MEMORANDUM

Subject: Construction of Yarbrough dock at 2105 Island Cove.
File No. SP-00-2190DS.

Subject: Construction of Schimsk Boat dock at 2611 Westlake Dr.
File No. SP-00-2137DS.

Subject: Construction of Levin Boat dock at 4512 Island Cove.
File No. SP-00-2134DS.

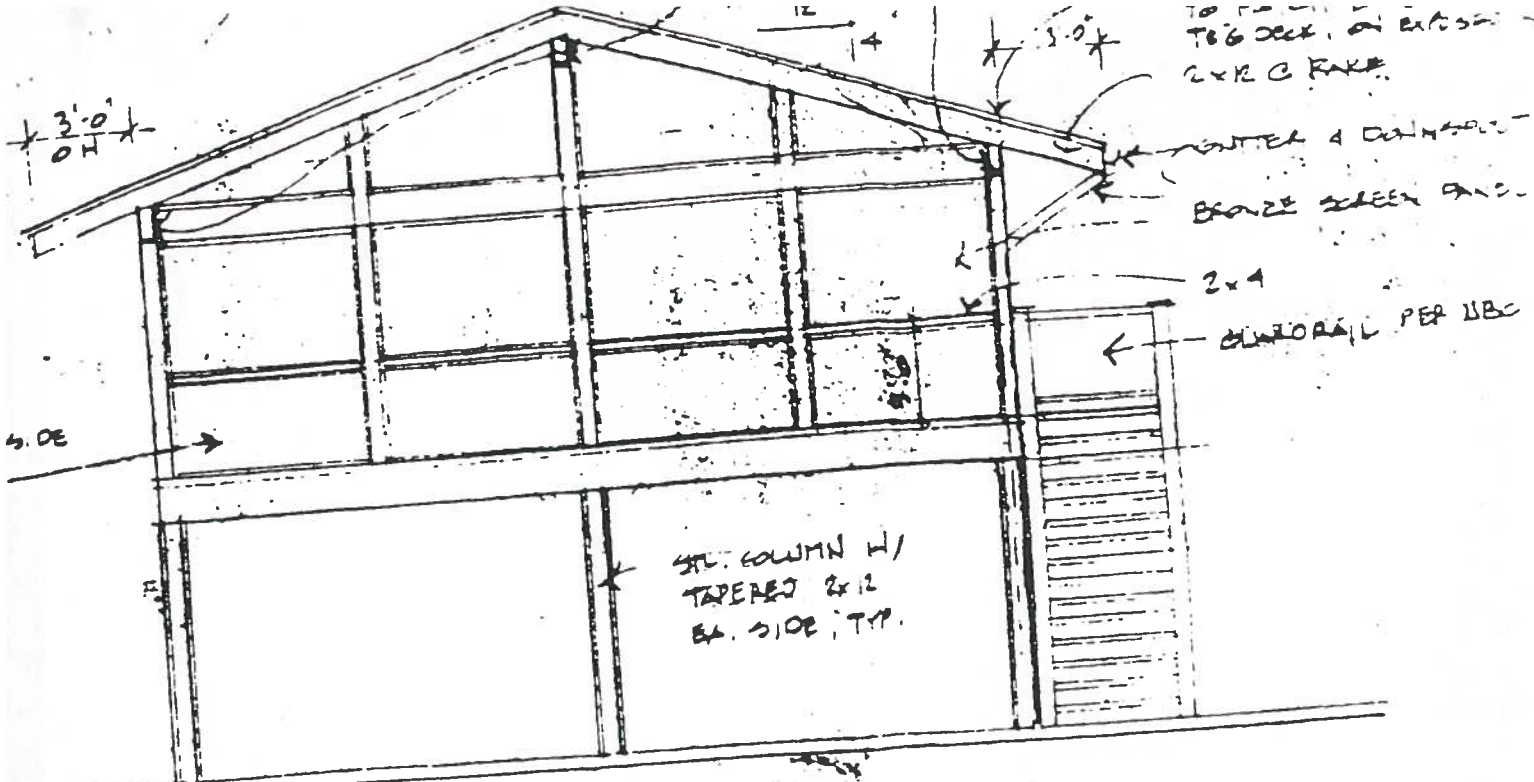
The Parks and Recreation Department (PARD) staff has reviewed plans for the proposed project and finds they meet the requirements of Article XIII, Section 25-2-1176, (Regulations for the Construction of Boat Docks) of the Land Development Code.

I recommend approval of the above request as detailed in the attached site plan.

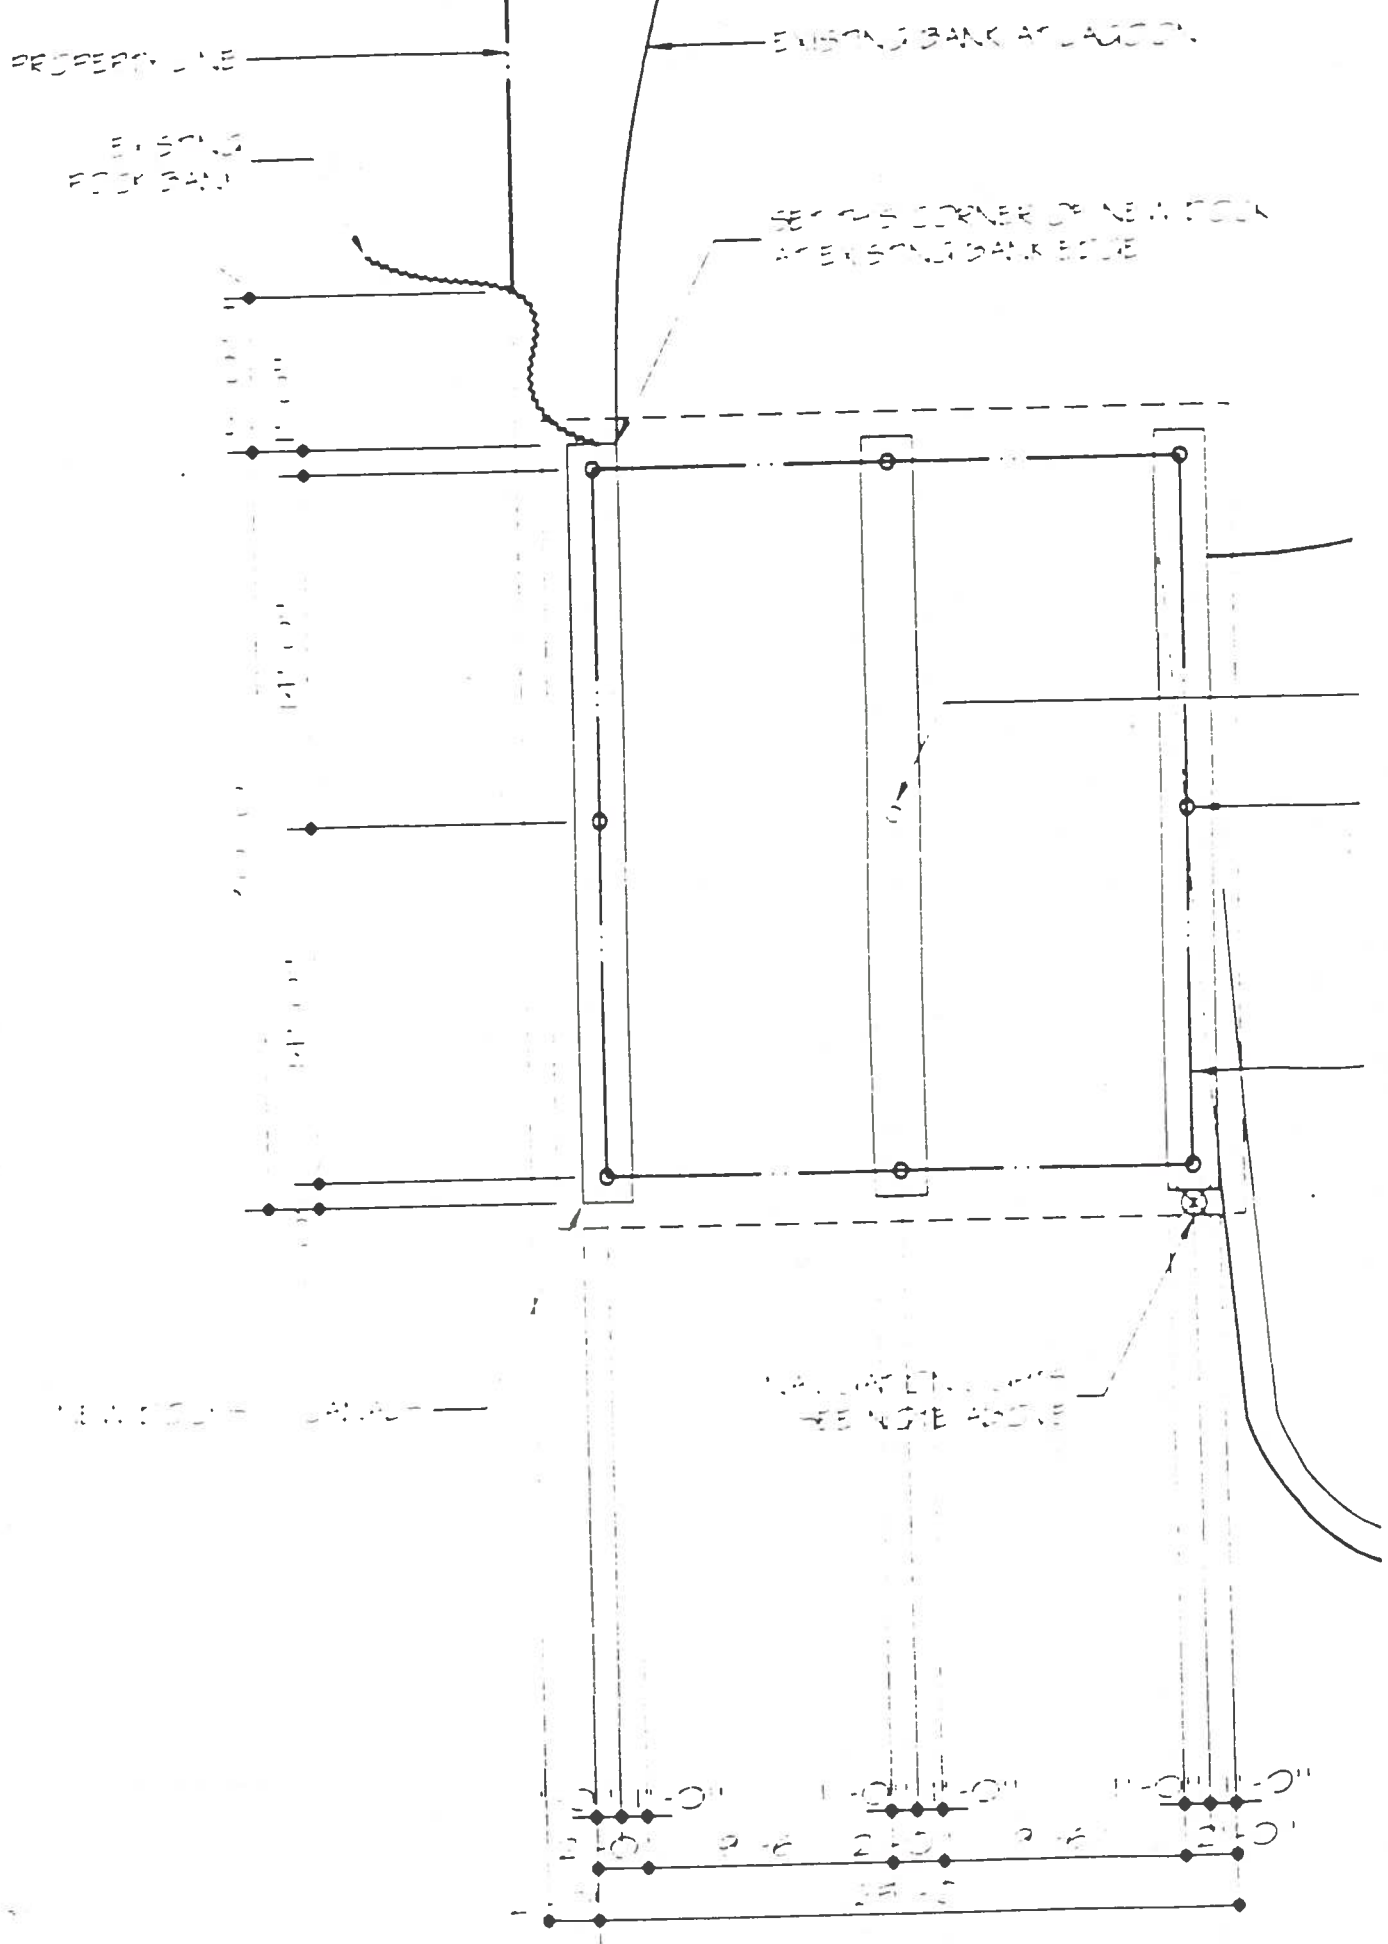
The Parks and Recreation Department (PARD) staff has reviewed plans for the proposed project and finds they meet the requirements of Article XIII, Section 25-2-1176, (Regulations for the Construction of Boat Docks) of the Land Development Code.

I recommend approval of the above request as detailed in the attached site plan.
